City Council Agenda Memo

SUBJECT: Plat Waiver to the Maximum Block Length for Director's Park Subdivision

Re: Preliminary Plat of Directors Park Subdivision

PRELIMINARY PLAT OF DIRECTORS PARK SUBDIVISION ABILENE, TAYLOR COUNTY, TEXAS

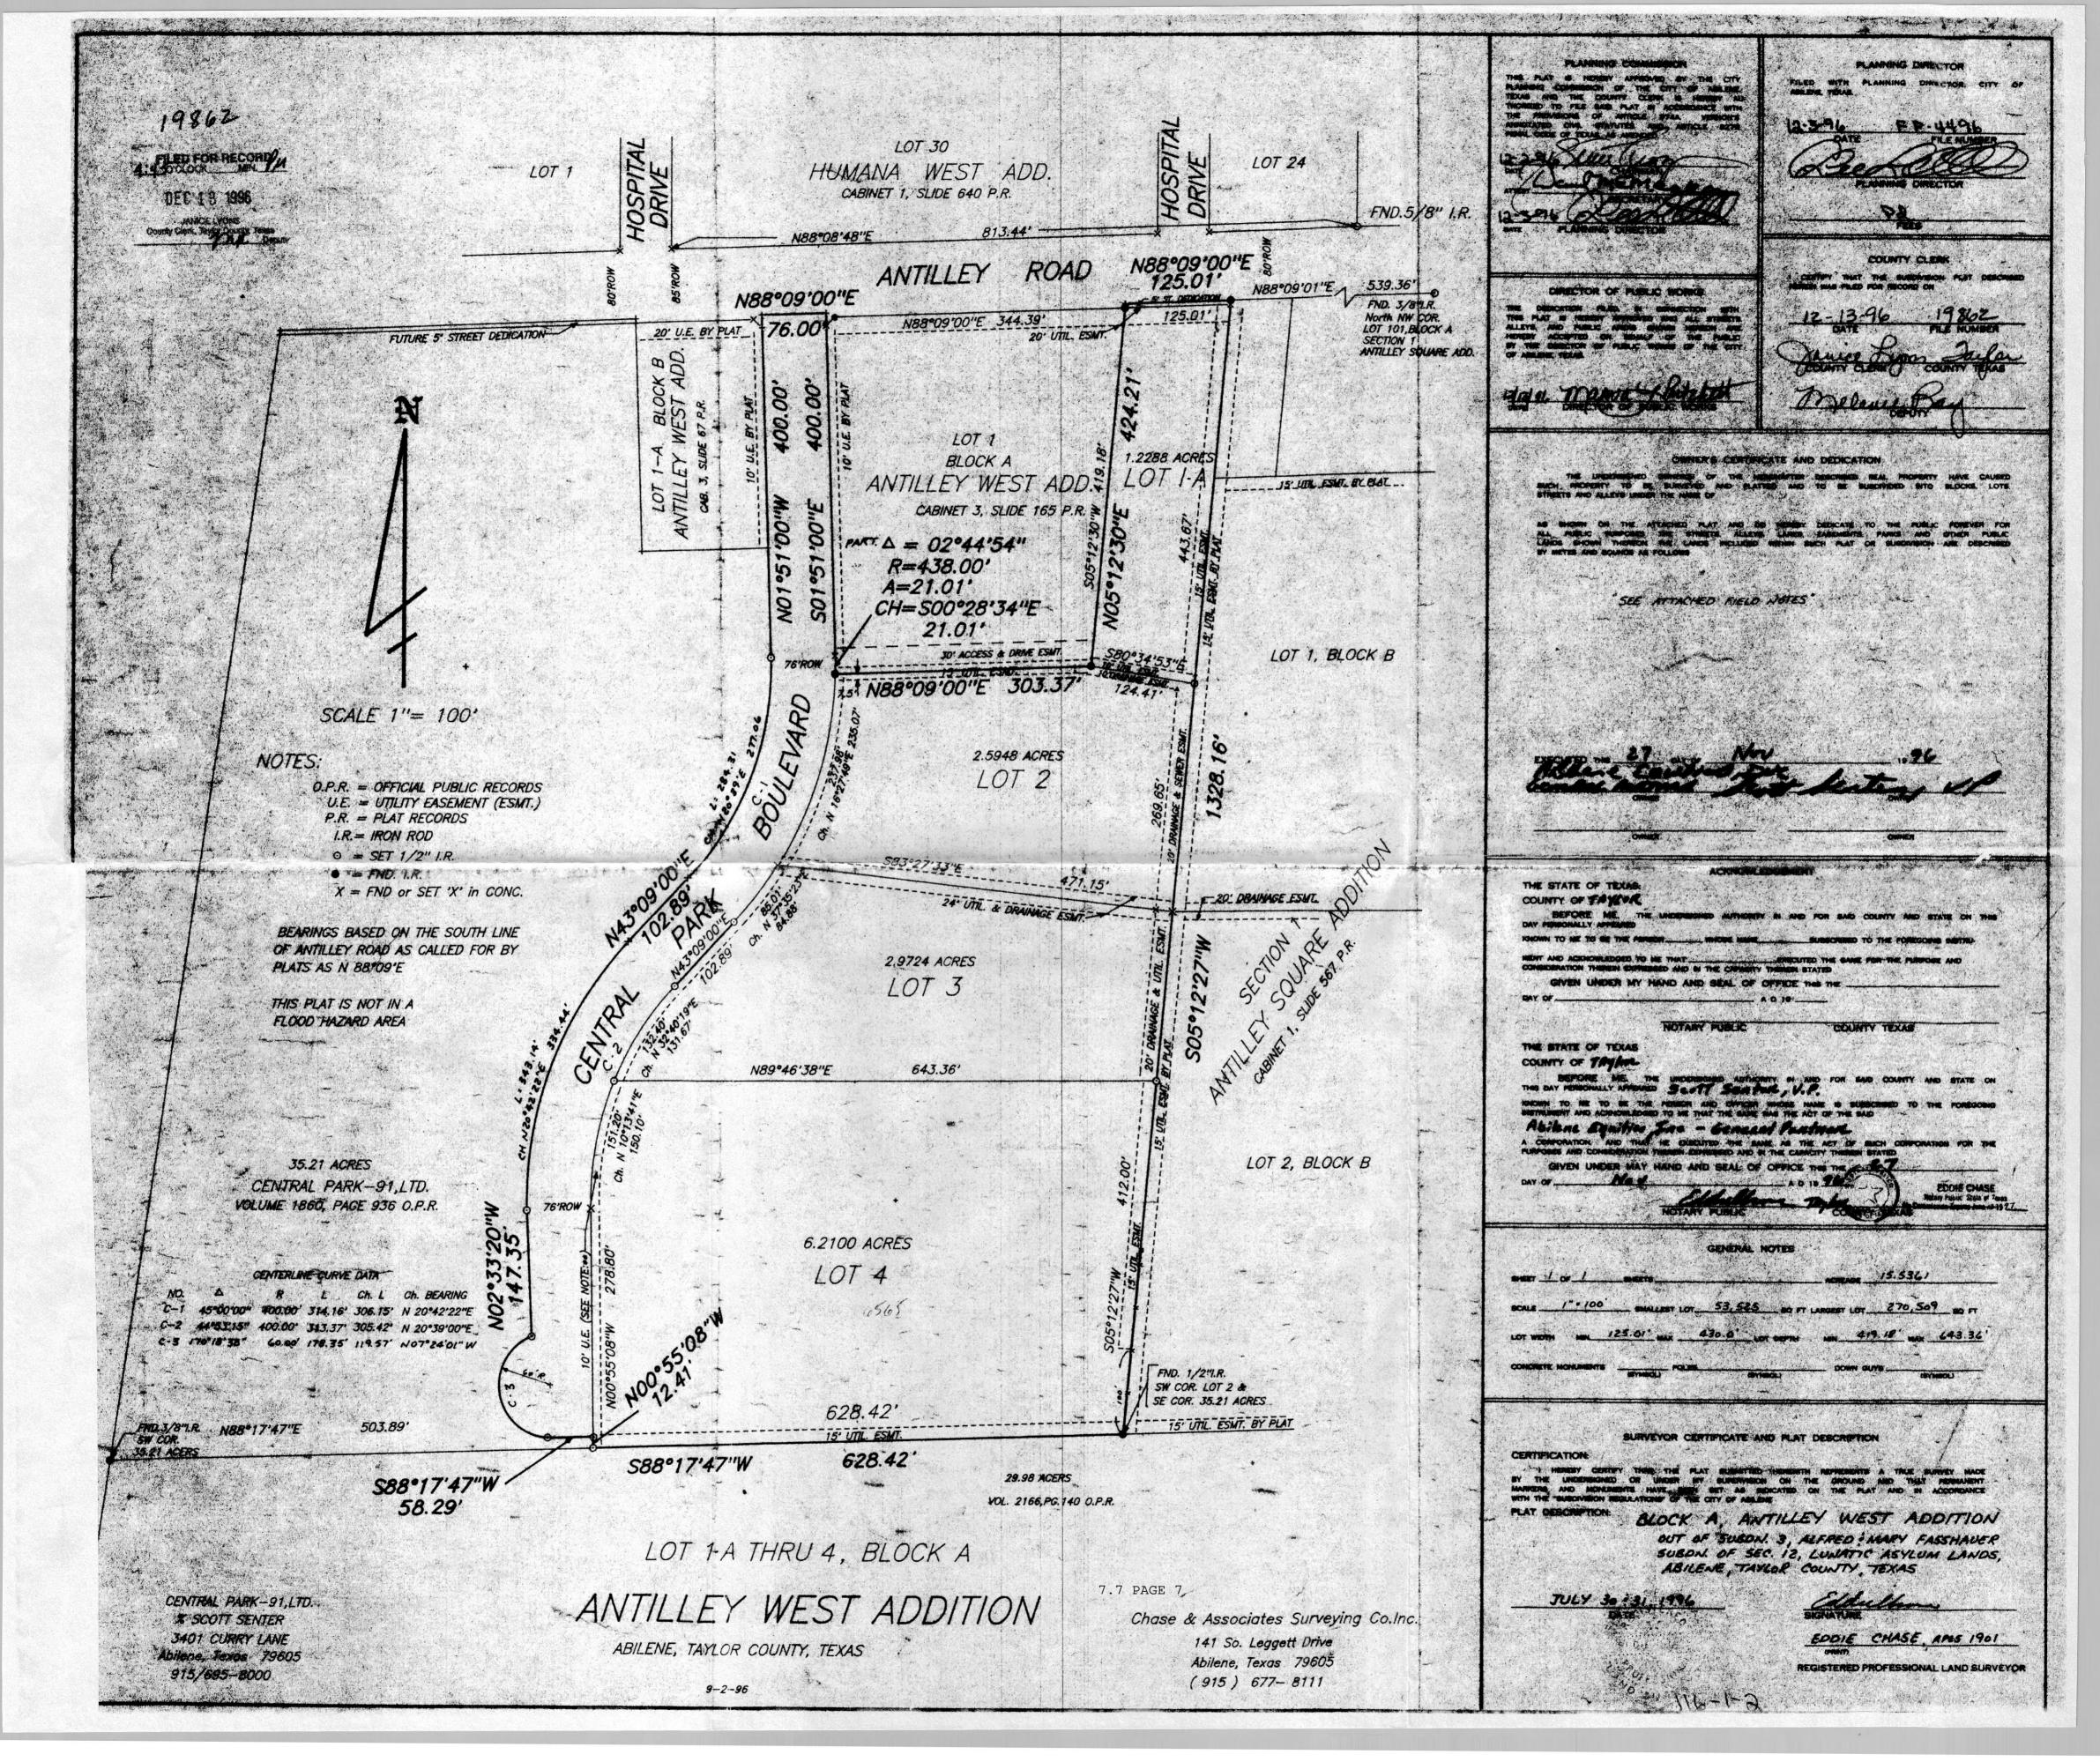
In review of the plat, staff made a comment that a street connection be provided to the north to allow for connection with Central Park Blvd. Although this does not resolve the block length to the east, it significantly improves the overall block length along the entire length of the north boundary. Based on the exhibit provided in the approved PD zoning, there was intent for connection to Central Park Blvd at one time and the connection would help with connectivity. Although the plat to the north shows that the street ended 12.4 feet from the south boundary, the remaining property to the south and west remains un-platted. A future plat for this property will require right-of-way dedication and construction of the remaining 12.4 feet of roadway. The purpose of the plat to the north was to dedicate a private street to the public and to subdivide lots for development on the east side of the street. As part of the approval process, improvements to the private street were required in order to be accepted by the City. A letter from the City Engineer outlined the needed improvements. This did not address future dedication and extension of the road from the remaining un-platted property to the west.

Comments received on the above mentioned preliminary plat required a stub-out street to the north as per Chapter 3, Article 2, Section 3.2.7.8(a) and a recommendation that the stub-out be Central Park Blvd. The developers of both Directors Park Subdivision and Antilley West Addition are requesting a waiver from subdivision requirements as per Chapter 1, Article 3, Division 4 – Petition for Waivers of the LDC.

- 1. The developer of Directors Park Subdivision is planning on the streets within his development to be private and gated. As with all gated communities, residents demand limited access into the development and the upscale development desired cannot be accomplished.
- 2. The developers of Antilley West Addition went to great lengths in 1996 to get this previously private street dedicated to the City of Abilene. The right-of-way with an additional cul-de-sac was platted and additional construction was required before acceptance by the City of Abilene. Right-of-way dedication was not continued to the south property line, indicating all parties agreed not to extend Central Park Blvd. to the south. There exists current City staff that were involved in this decision. Also, there are existing utilities that cross at the end of Central Park Blvd. that could require adjustment or relocation.

Both of these developers are part of the team that is dedicating and constructing Memorial Drive South. This street is being extended to provide the north/south connection required. This proposed road is just 500 feet west from Central Park Blvd. and is being constructed 3 feet wider than required by the LDC.

Staff recommends denial of the requested plat waiver.

The Planning and Zoning Commission recommends approval as requested by a vote of 4 in favor (Bixby, Glenn, Rosenbaum, and McClarty), none opposed, and 1 abstained (Todd).
